Suite 217-  
ORIGINAL (SALES)  
(INVENTORY SUITE)

SAG HARBOUR: 217

SUITE 217 - SAG HAF R .  
HAMPTON PLACE 25 Baker Hill Bk  
Jfkville, ON Jan 23, 2018  
DRAWING AS PER AGREEMENT OF PURCHASE AND SALE (before decor appointment)

Suite: 217 - Inventory Suite  
w/ STO Appliance Package

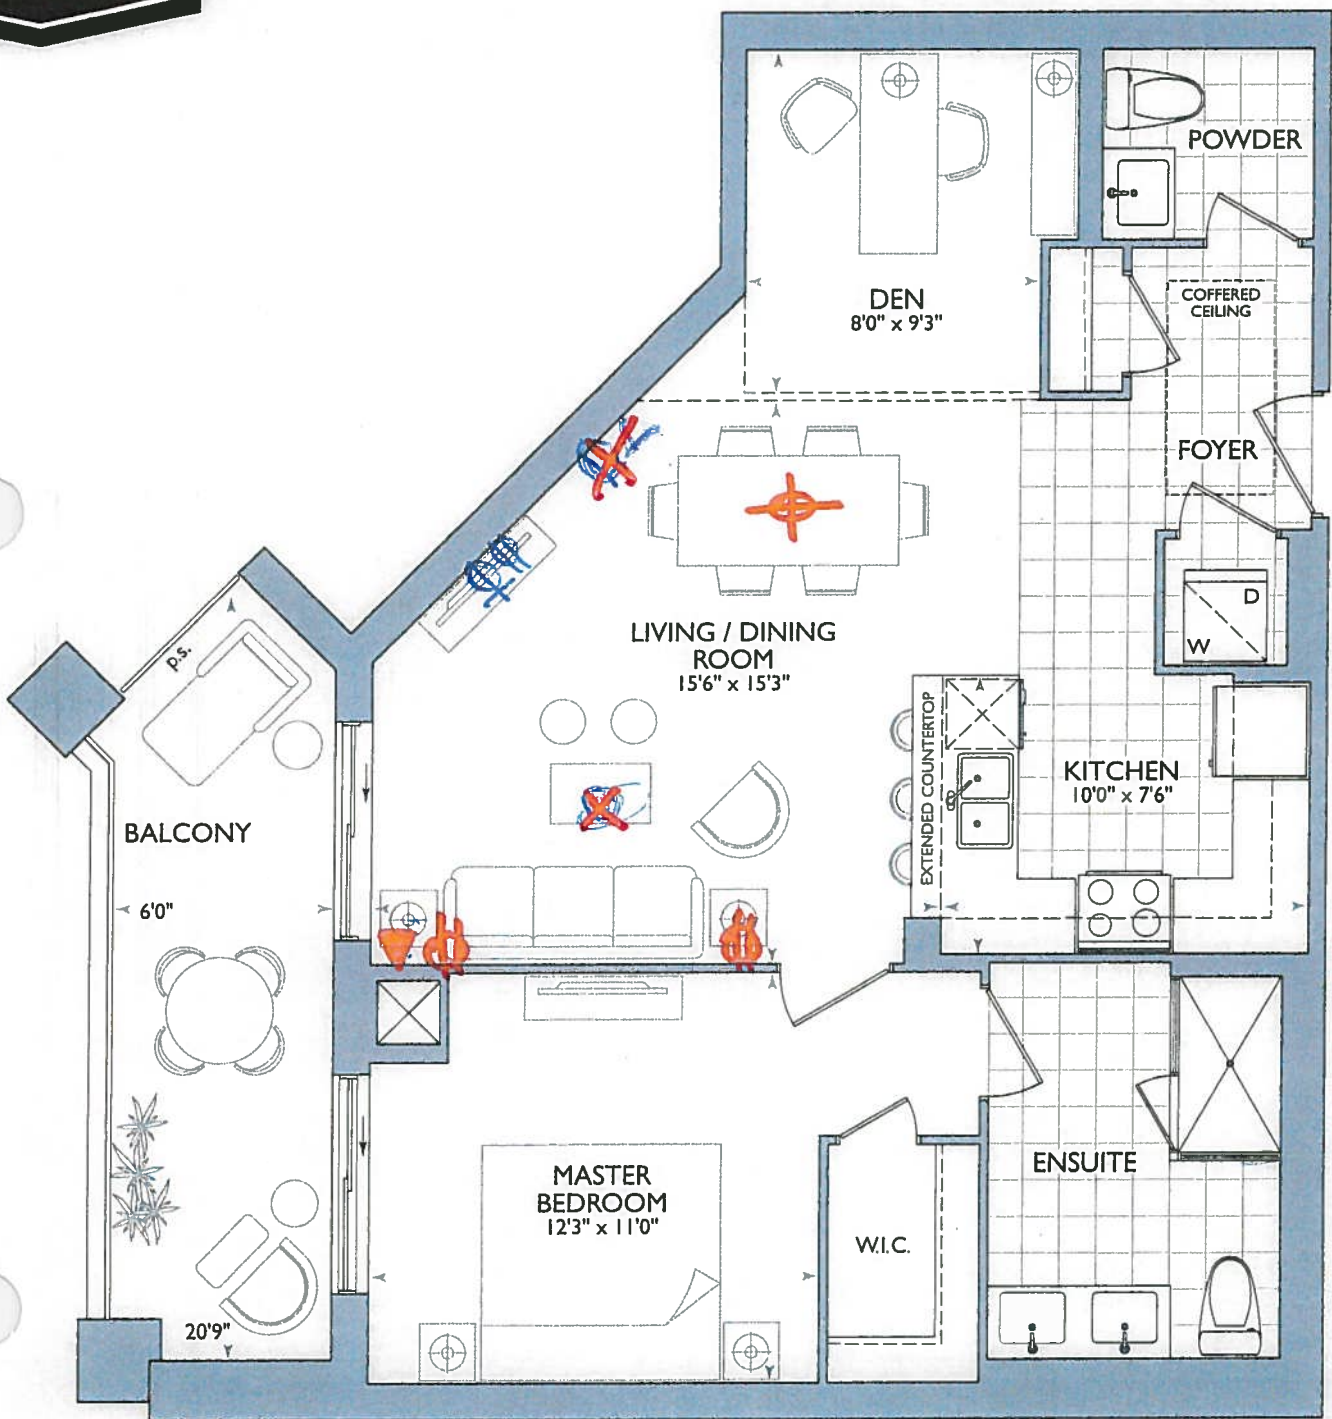
- MOVE FRONT DOOR (FOR 6" WALL BEHIND WASHER/ DRYER)

\*Front Door move \*  
Due to Laundry Room  
Kitchen size .
